# Imray Correction Notice ICC28-4

10 September 2020

## Chart **C28** WGS 84 Edition 2017

# RIVER DEBEN ENTRANCE

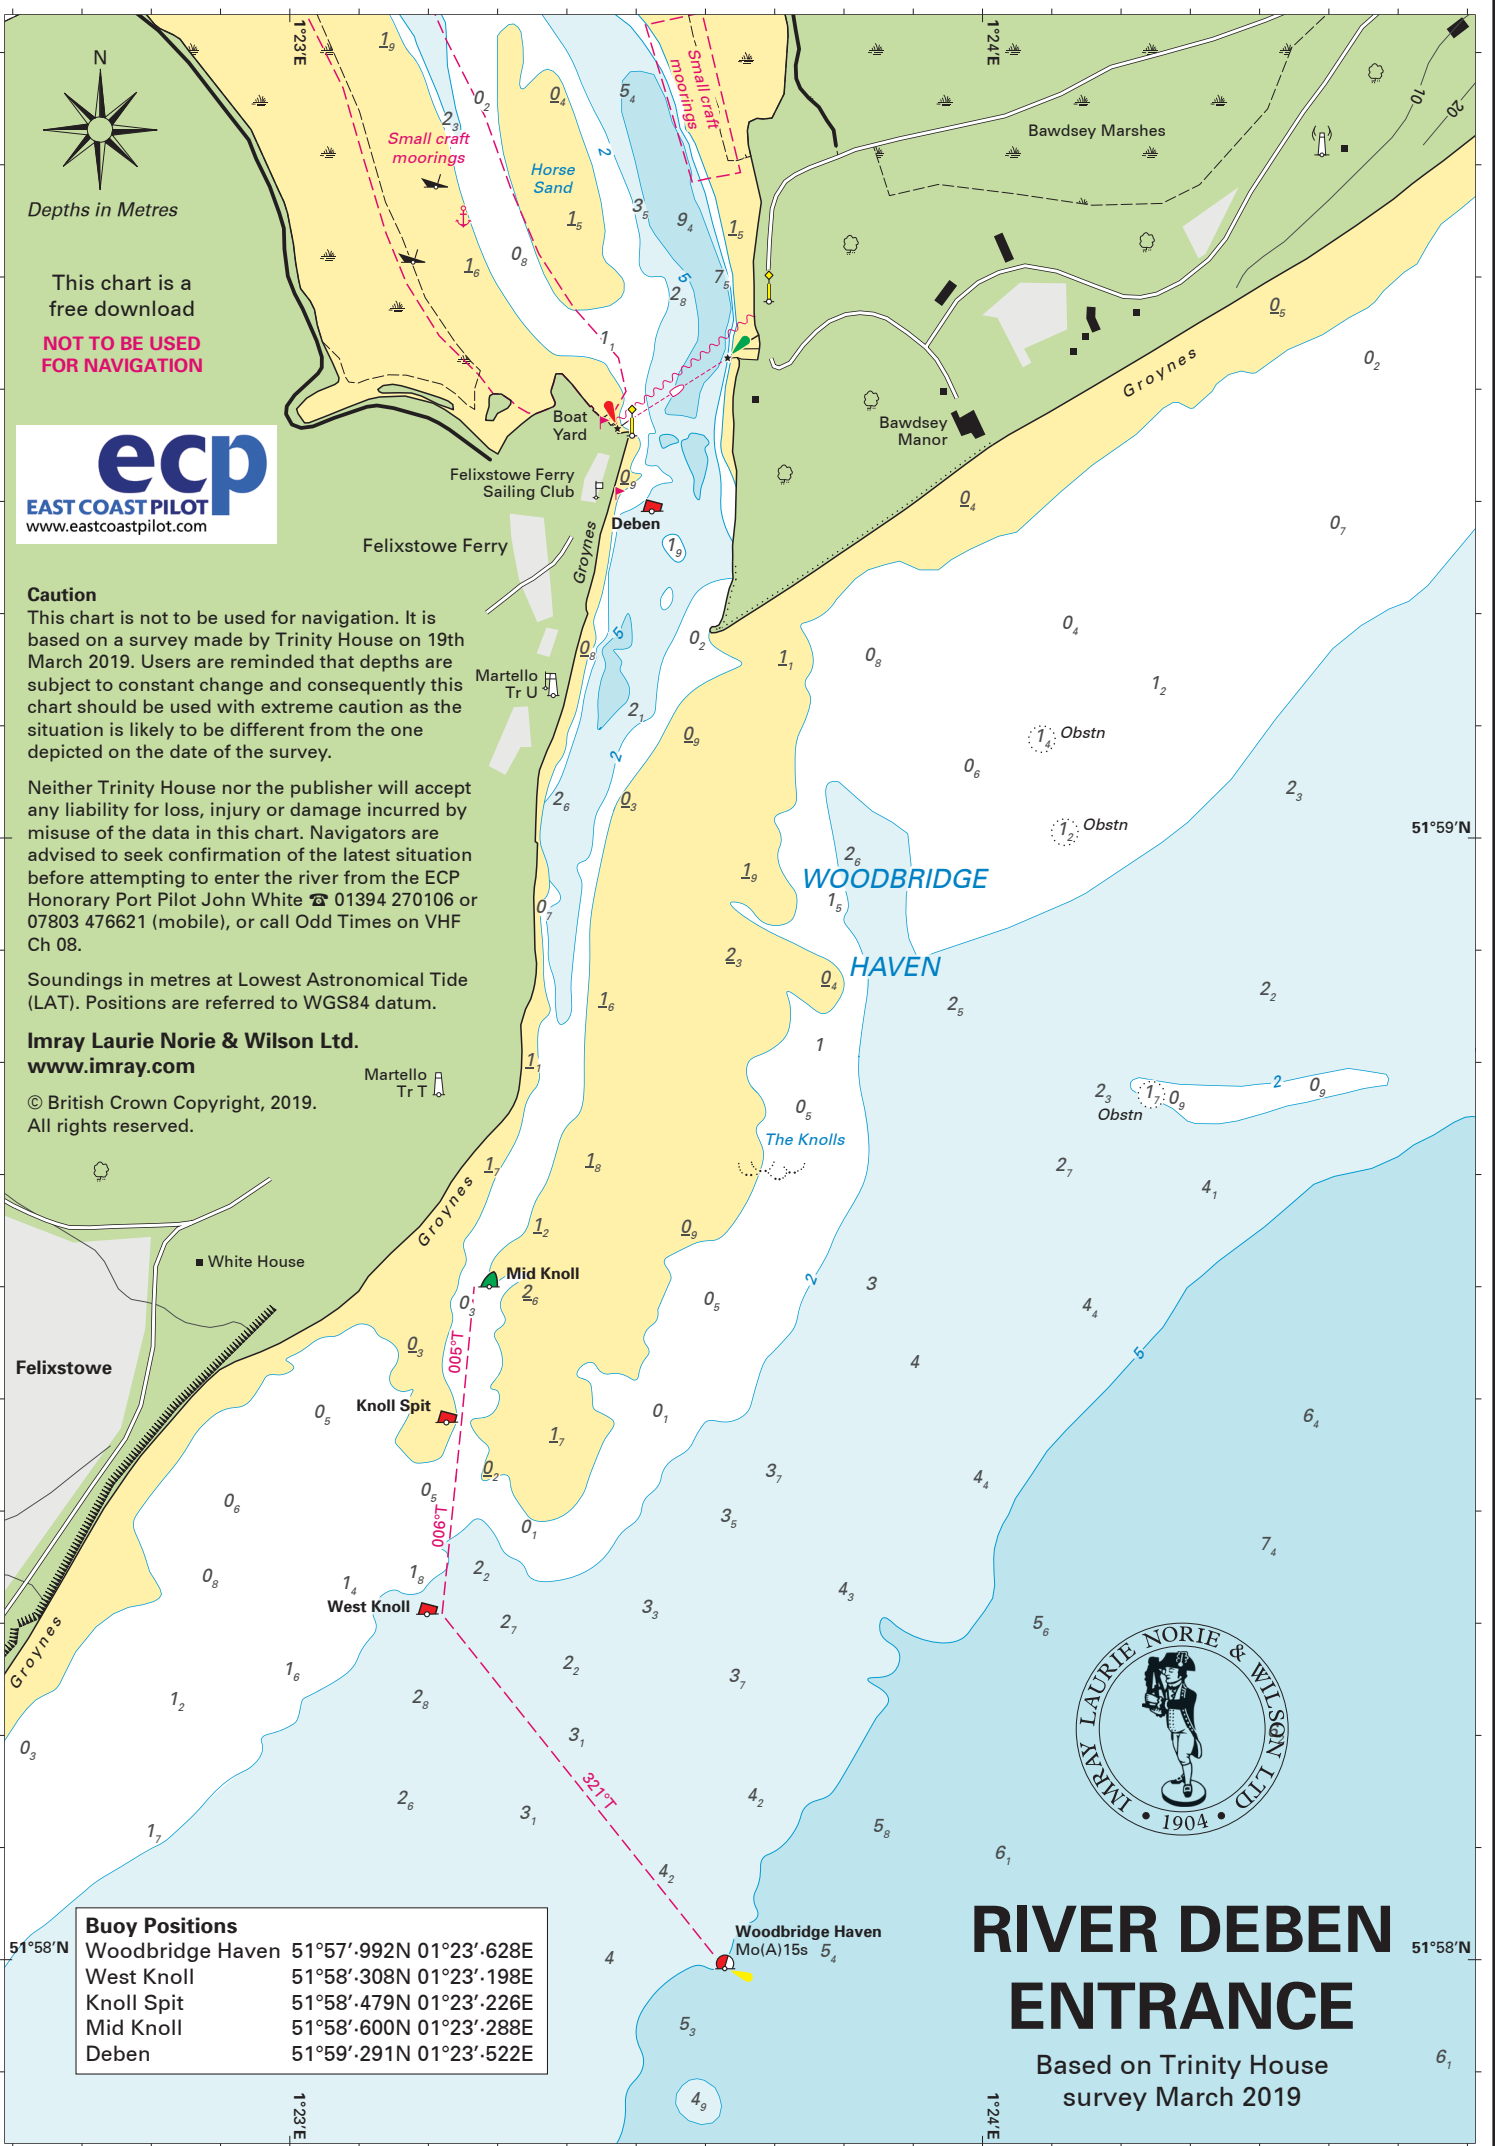
For detailed information about the River Deben entrance yachtsmen are advised to consult the accompanying chartlet (revised 03/19) (ILNW 171/19)

Buoy Positions	
Woodbridge Haven	51°57'.992N 01°23'.628E
West Knoll	51°58'.308N 01°23'.198E
Knoll Spit	51°58'.479N 01°23'.226E
Mid Knoll	51°58'.600N 01°23'.288E
Deben	51°59'.291N 01°23'.522E

# RIVER ORE ENTRANCE

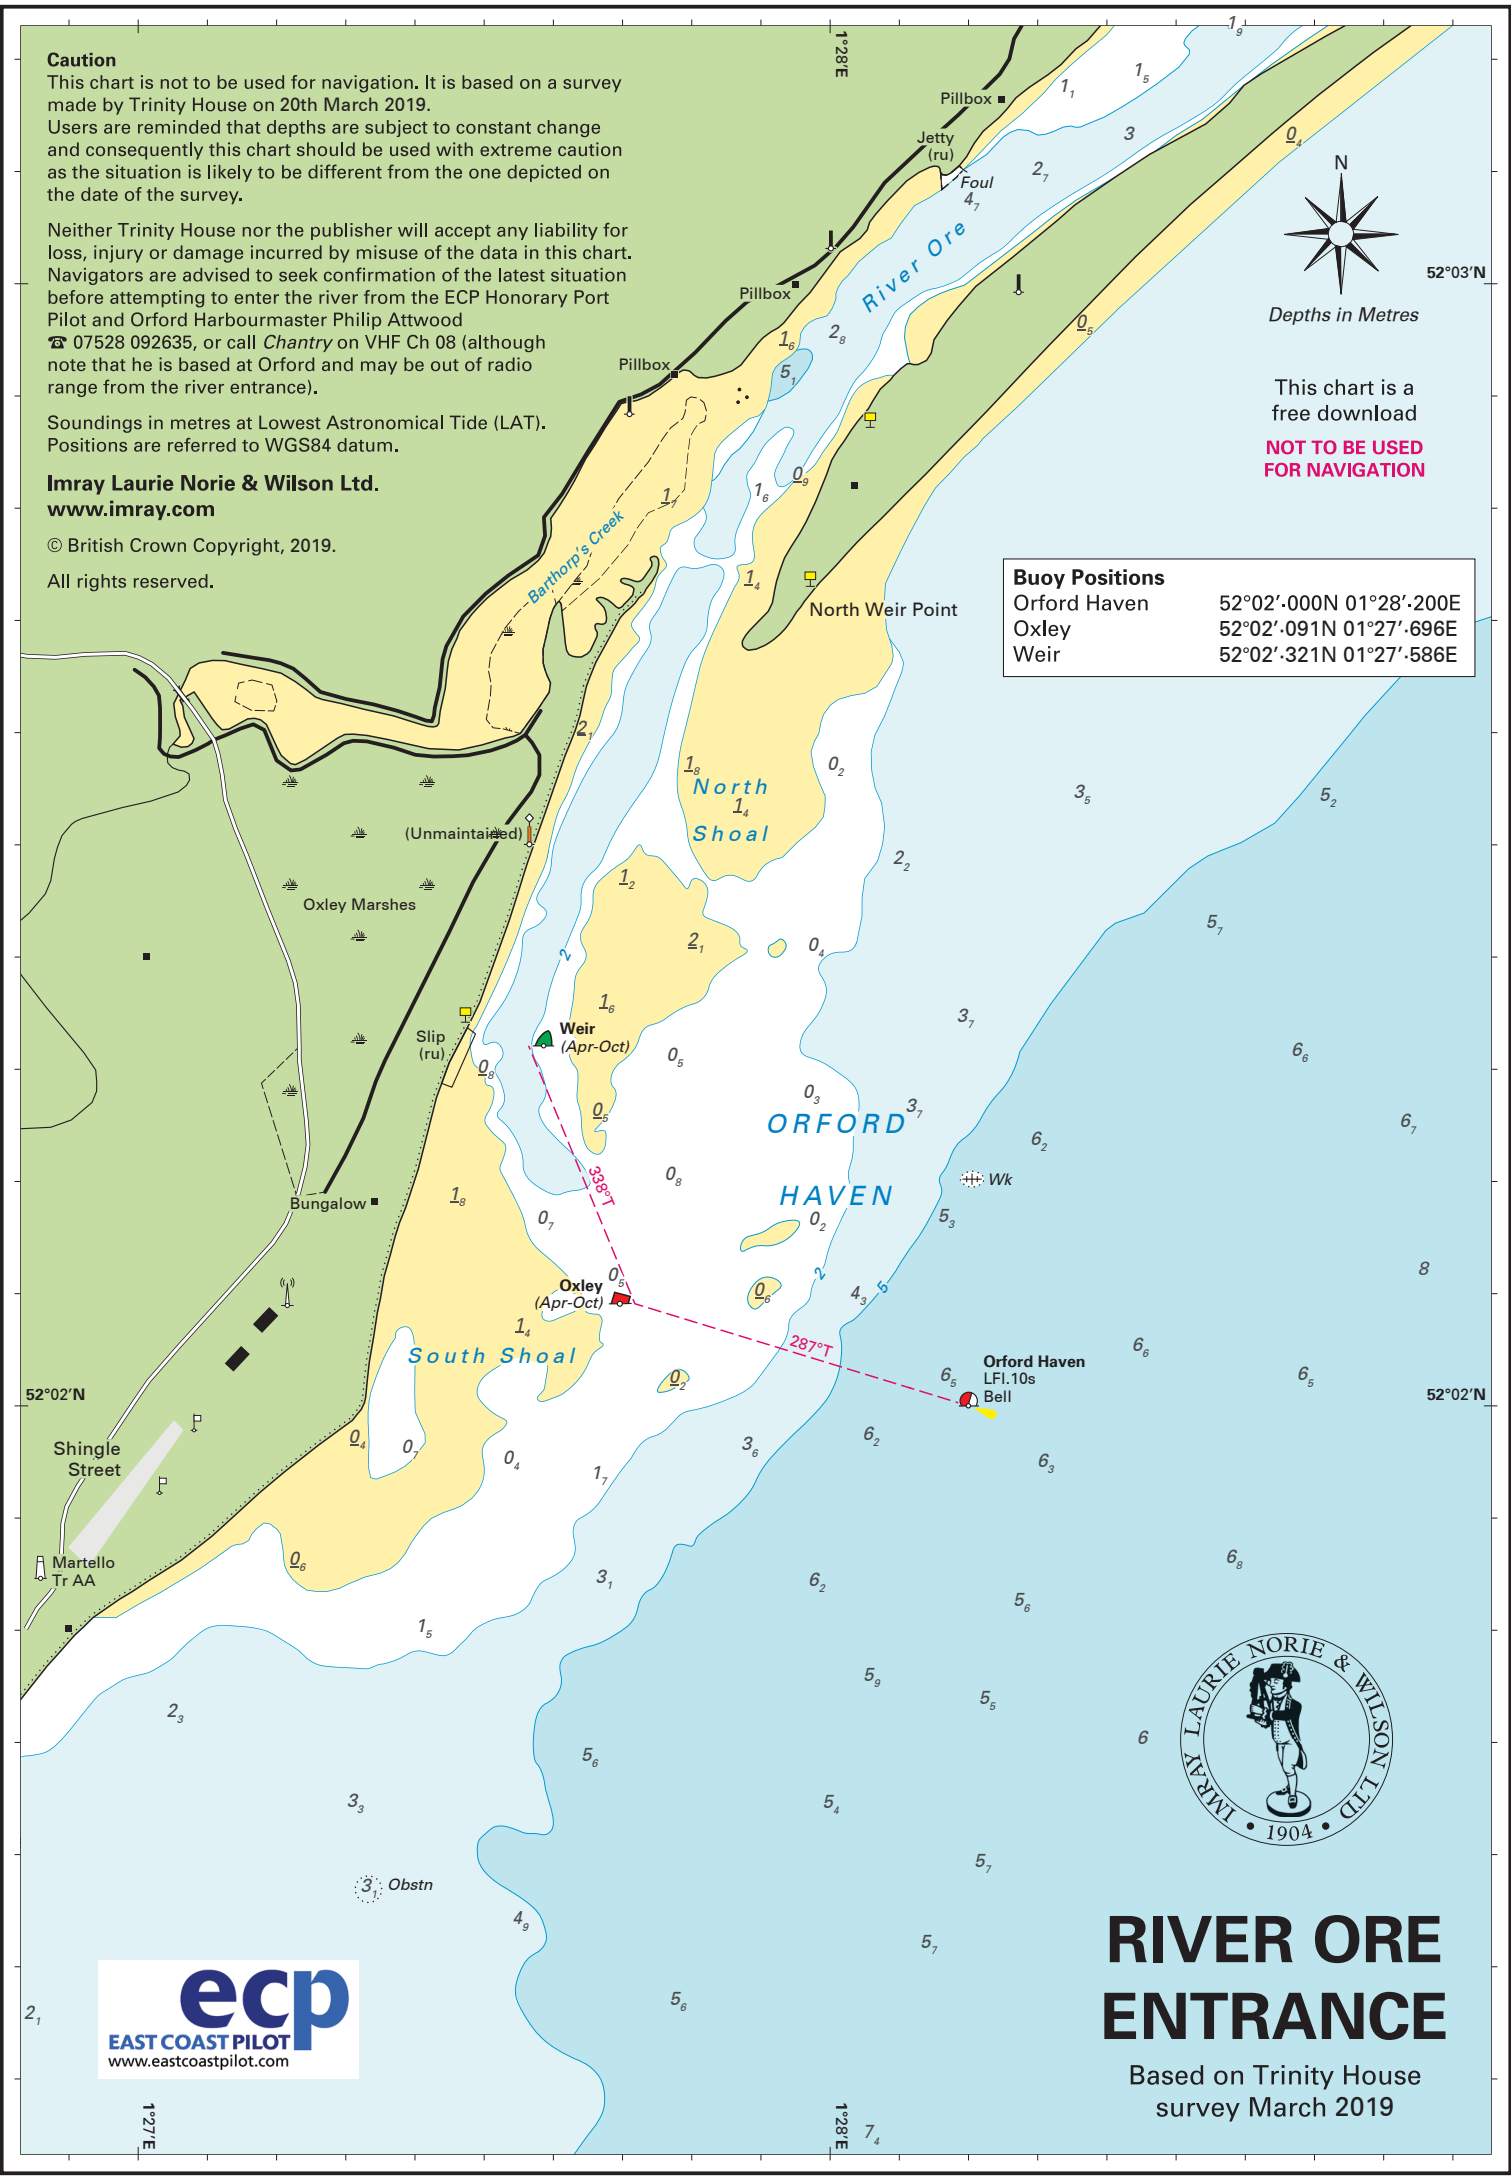
For detailed information about the River Ore entrance yachtsmen are advised to consult the accompanying chartlet (revised 03/19) (ILNW 170/19)

Orford Haven	52°02'.000N 01°28'.200E
Oxley	52°02'.091N 01°27'.696E
Weir	52°02'.321N 01°27'.586E
